Product Change Notice (PCN)

PCN Number: PCN-0450011R-01

Product(s) Affected: PJ-069B-SMT-TR

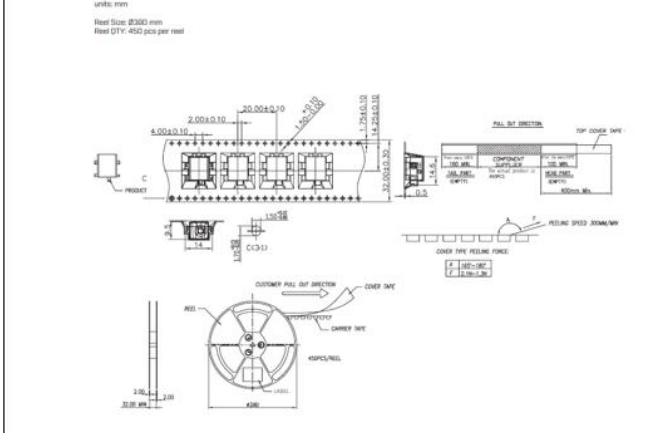
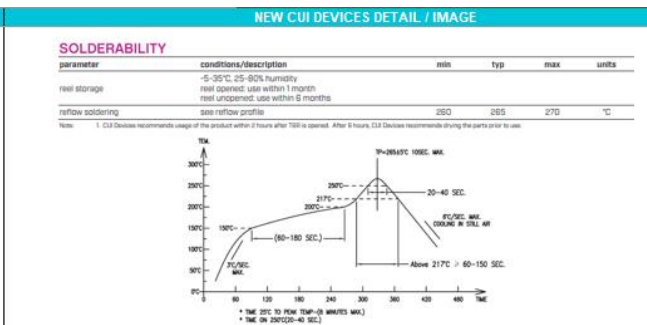
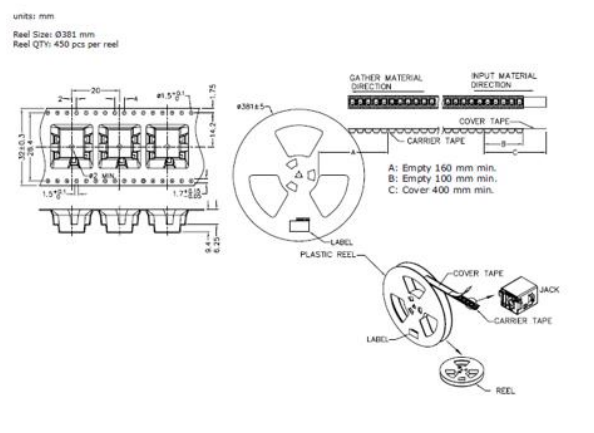
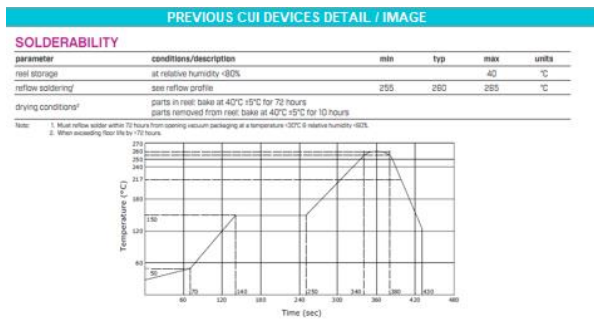
Description of Change: *Materials and packaging update*

PREVIOUS CUI DEVICES DETAIL / IMAGE	NEW CUI DEVICES DETAIL / IMAGE																																																
 <p>Recommended PCB Layout Top View</p>	 <p>Recommended PCB Layout Top View</p>																																																
<table border="1"> <thead> <tr> <th></th> <th>MATERIAL</th> <th>PLATING</th> </tr> </thead> <tbody> <tr> <td>center pin</td> <td>brass</td> <td>nickel</td> </tr> <tr> <td>terminal 1</td> <td>brass</td> <td>silver</td> </tr> <tr> <td>terminal 2</td> <td>copper alloy</td> <td>silver</td> </tr> <tr> <td>terminal 3</td> <td>brass</td> <td>silver</td> </tr> <tr> <td>shield-A</td> <td>brass</td> <td>nickel</td> </tr> <tr> <td>shield-B</td> <td>stainless steel</td> <td></td> </tr> <tr> <td>plastic</td> <td>PA6T or equivalent</td> <td></td> </tr> </tbody> </table>		MATERIAL	PLATING	center pin	brass	nickel	terminal 1	brass	silver	terminal 2	copper alloy	silver	terminal 3	brass	silver	shield-A	brass	nickel	shield-B	stainless steel		plastic	PA6T or equivalent		<table border="1"> <thead> <tr> <th>DESCRIPTION</th> <th>MATERIAL</th> <th>PLATING/COLOR</th> </tr> </thead> <tbody> <tr> <td>center pin</td> <td>copper</td> <td>nickel</td> </tr> <tr> <td>terminal 1</td> <td>brass</td> <td>silver</td> </tr> <tr> <td>terminal 2</td> <td>copper alloy</td> <td>silver</td> </tr> <tr> <td>terminal 3</td> <td>brass</td> <td>silver</td> </tr> <tr> <td>shield-A</td> <td>brass</td> <td>nickel</td> </tr> <tr> <td>shield-B</td> <td>stainless steel</td> <td></td> </tr> <tr> <td>housing</td> <td>PA10T (UL94V-0)</td> <td>black</td> </tr> </tbody> </table>	DESCRIPTION	MATERIAL	PLATING/COLOR	center pin	copper	nickel	terminal 1	brass	silver	terminal 2	copper alloy	silver	terminal 3	brass	silver	shield-A	brass	nickel	shield-B	stainless steel		housing	PA10T (UL94V-0)	black

MATERIAL	PLATING																																															
center pin	brass	nickel																																															
terminal 1	brass	silver																																															
terminal 2	copper alloy	silver																																															
terminal 3	brass	silver																																															
shield-A	brass	nickel																																															
shield-B	stainless steel																																																
plastic	PA6T or equivalent																																																
DESCRIPTION	MATERIAL	PLATING/COLOR																																															
center pin	copper	nickel																																															
terminal 1	brass	silver																																															
terminal 2	copper alloy	silver																																															
terminal 3	brass	silver

shield-A	brass	nickel																																															
shield-B	stainless steel																																																
housing	PA10T (UL94V-0)	black																																															
 <p>MATING PLUG Jack Insertion Depth: 8.2 mm</p>	 <p>MATING PLUG Jack Insertion Depth: 8.3 mm</p>
